Information note

N° 054/21

Removal of legacy International Rectified (IR) logo from tube and packing box affecting products from assembly location Tijuana, Mexico

Customer Information Package
Information Note: 054/21

Changes and identification

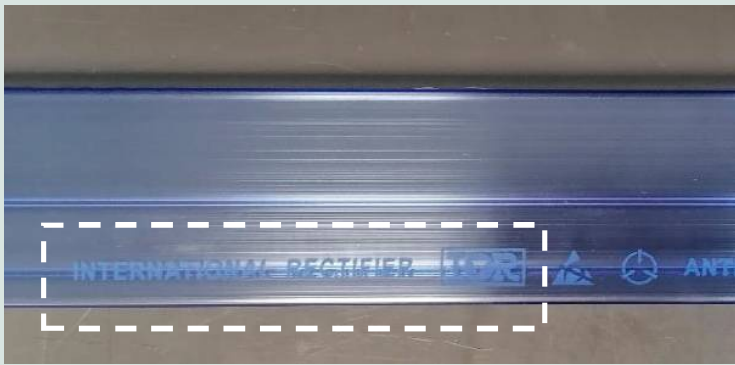
Before

After

“INTERNATIONAL RECTIFIER” + Logo removed
